**MODIFICATION OF HISTORIC DESIGN REVIEW CASE NO.: HIS20-31MOD1**

**SUMMARY:** A modification of a previously approved proposal to install signage on the exterior of the Reed Opera House.

**HISTORIC DESIGN REVIEW CASE NO. HIS20-31MOD1  
DECISION**

**EXHIBIT K**

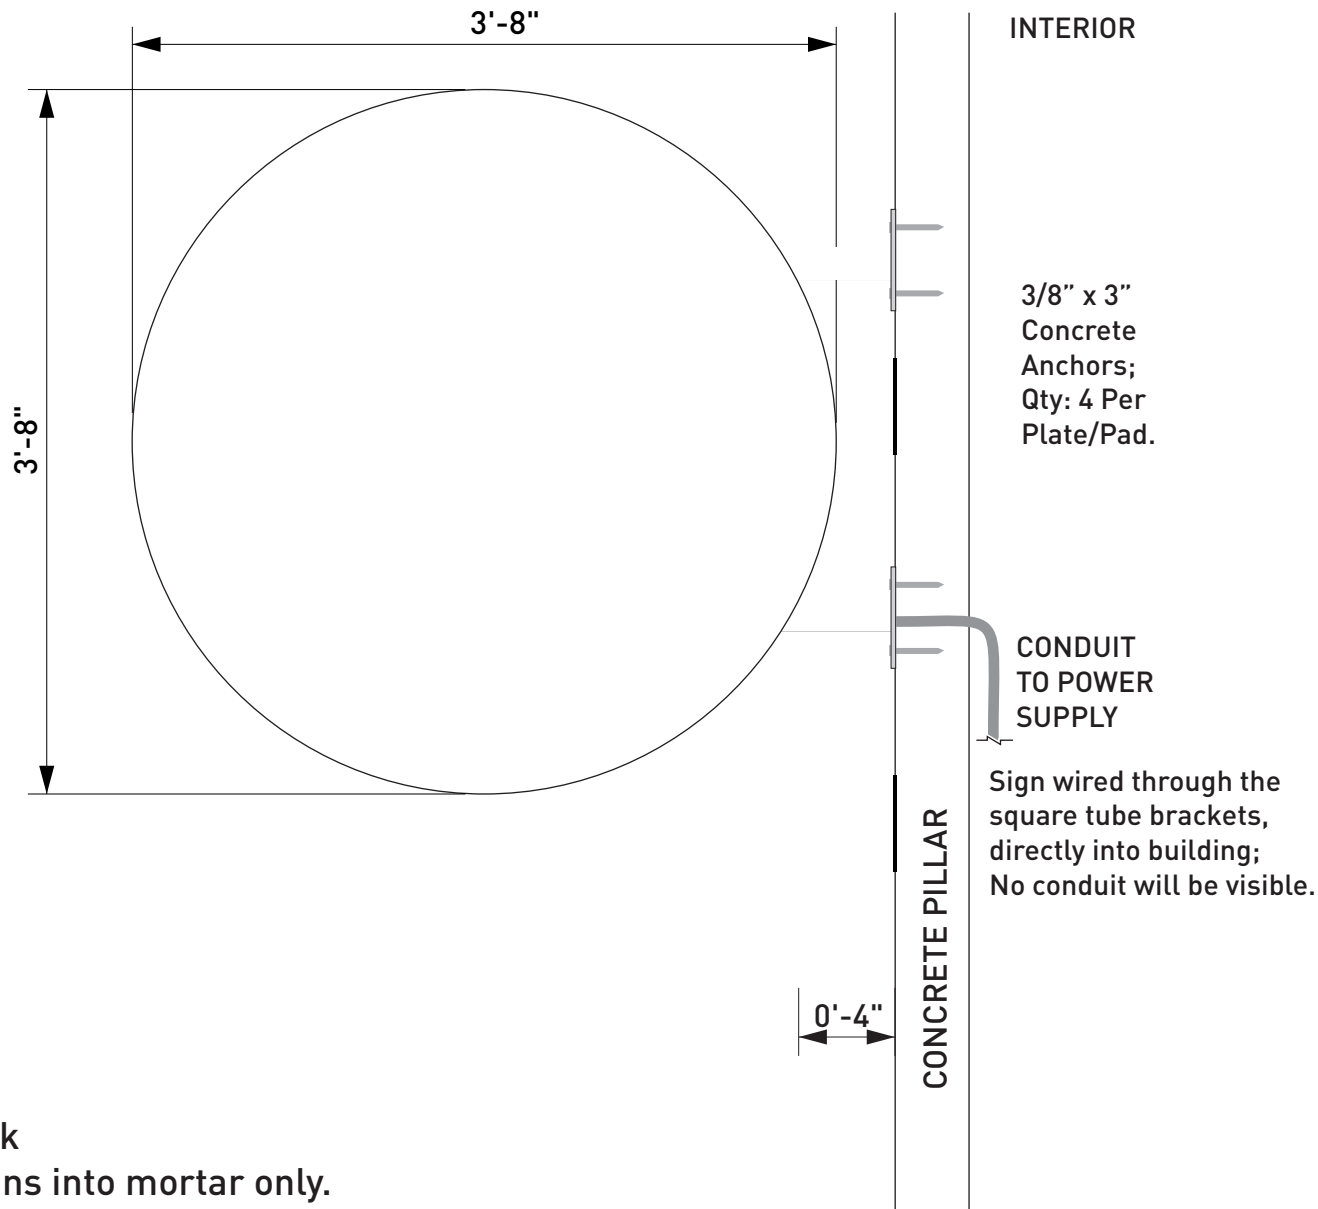
**Finding:** The applicant's proposed illuminated signage (3 projecting signs) all have conduit which will be wired through the square tube brackets directly into the building per Exhibit K in **Attachment B**. No conduit will be visible therefore staff finds that this standard has been met.
